RE: **Premier M.H Display Yard**
Grading Plan
Engineer's Stamp Date 9/15/17
Hydrology File: M14D012C2

**2700 BROADWAY BLVD., SE
A PREMIER DEVELOPMENT
Site - Grading &
Drainage Plan**

RE: COA M14/ D012C2 – Premier M.H. Display Yard

SWALE SECTION

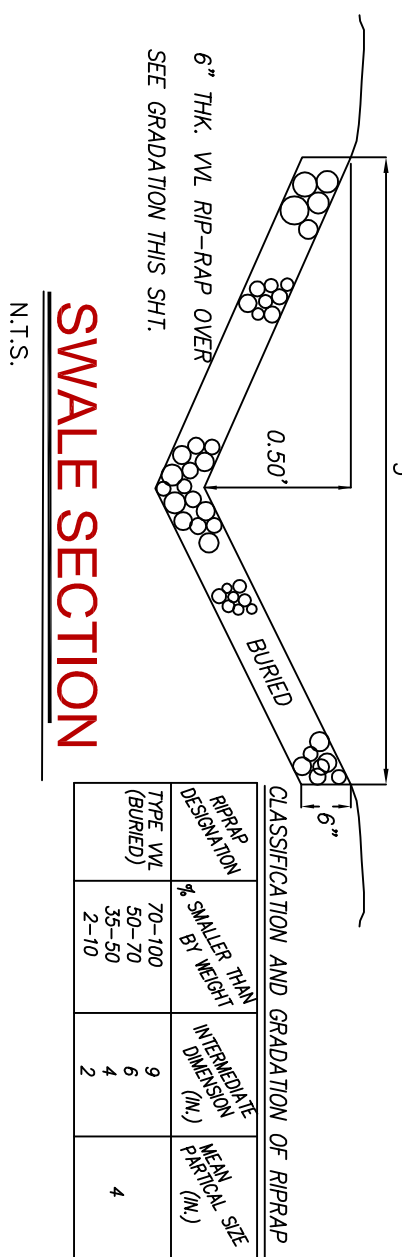
7. Hydraulic calculations must be added to the plan for the emergency overflow spillway.
8. Show the existing curb on lot 1-A-2, and specify location and length of opening in the curb to allow passage of the peak 100 year flow rate and provide hydraulic calculations for the opening. Extend the swale limits all of the way to the opening in the existing curb.

CMU RETAINING WALL @ PL

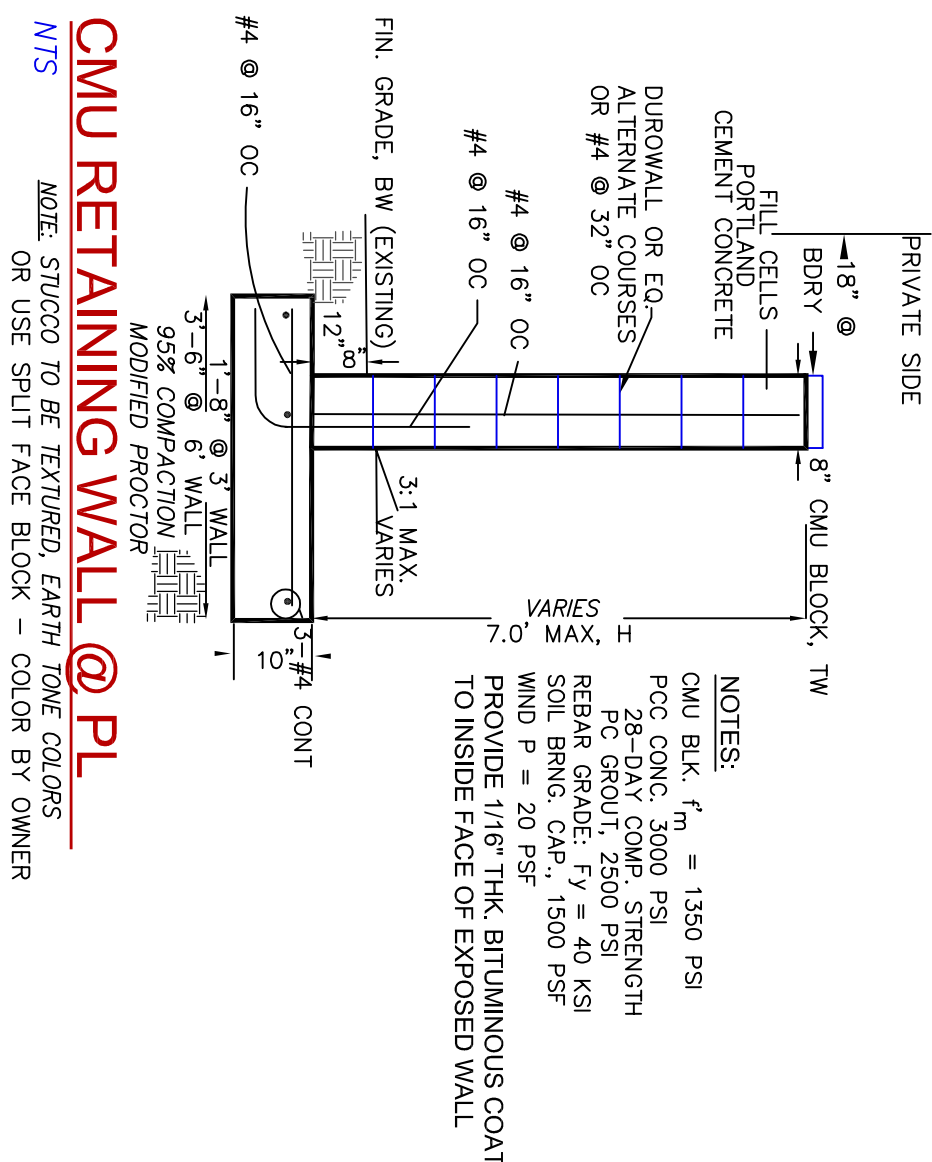
5. The spot elevations along the south property line must be lower so that slope between the curb and right of way does not exceed 2%.
6. Provide pond wall design calculations stamped and signed by a NMPE. Hydrology will review the calculations since this is a drainage structure, but the wall will also require a separate building permit. Hydrostatic forces should be assumed to act on the underside of the footing. A core trench of impervious material is needed to prevent seepage under the footing. The drainage wall must be extended to higher ground on the ends. The wall material should be changed to concrete instead of block.

7. Comply, and have added Section, specs, and bituminous call-out in order to provide waterproofing of inside face of wall.
8. Comply, and have used weir eq. to size emergency spillway at approx. $L = 17'..@$ natural outfall
9. Concur – deleted the face of curb dimension statement. Thank you. Added call-out to remove the bee-hive inlet. Revisiting the existing contours should note that the existing positive drainage patterns will be to the west.
10. The approved drainage basin to the east for lot A1-2 encompassed the entire lot, therefore, the estimated off-site basin is 0.65 acres, and not necessary to be repeated / reiterated, nor shown. The resulting run-off values of that approved plan are called-out at the common boundary in order to assist in review, and referenced by M14/D012C2.
